40 CFR Part 63

National Emission Standards for Hazardous Air Pollutants for Source Category: Pulp and Paper Production

ACTION: Proposed rule amendments and notice of public hearing.

Figure 1. Proposed Changes to Daily Monitoring Requirements for Open Biological Treatment Systems

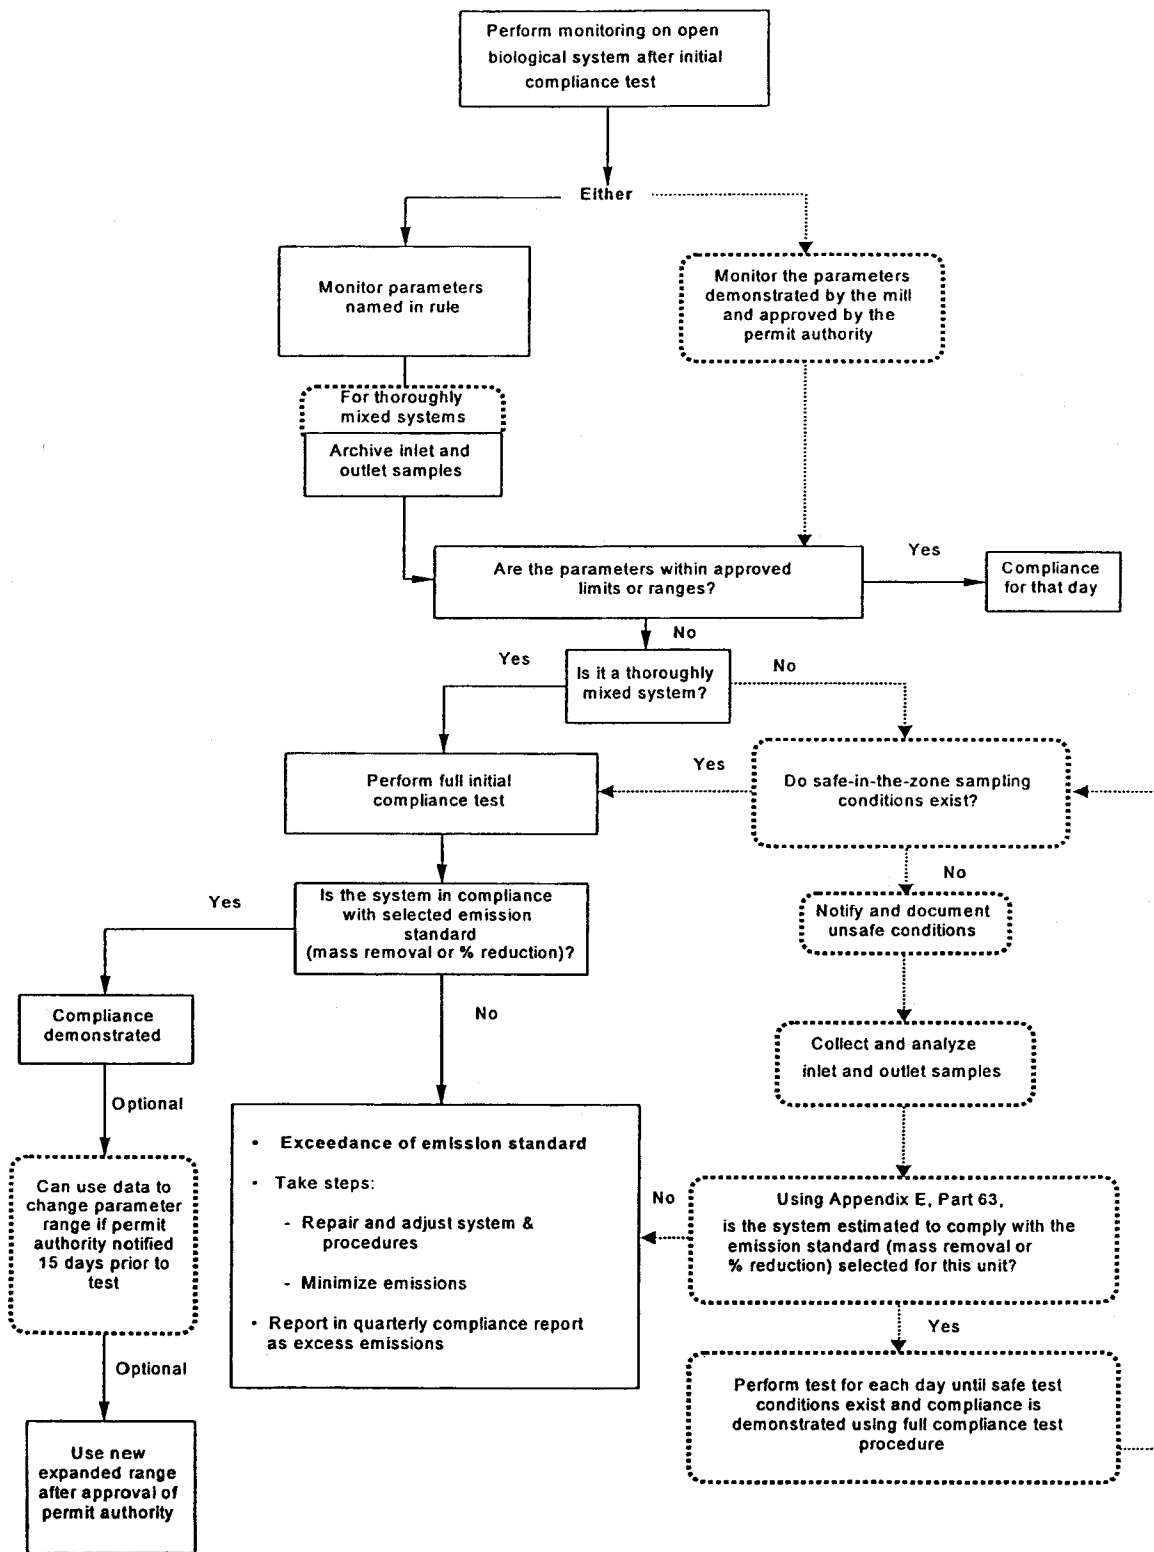
The flow diagram shown in figure 1 summarizes the daily monitoring

requirements for open biological treatment systems. In figure 1, today's proposed changes are depicted by dashed lines and rounded boxes.

Mills must monitor on a daily basis either the parameters specified in the final rule (§ 63.453(j)(1)) or site-specific parameters that have been approved (proposed § 63.453(j)(2), see section I.E.2 of this preamble). If the monitoring parameters are within the values or ranges established during the initial performance test, compliance with the applicable emission standard is demonstrated for that day. If the monitoring parameters are outside the established values or ranges, you must conduct a performance test to confirm compliance of the open biological treatment system. The performance test must be performed using the same procedures (*i.e.*, the appropriate procedures in appendix C of part 63) that were followed during the initial performance test.
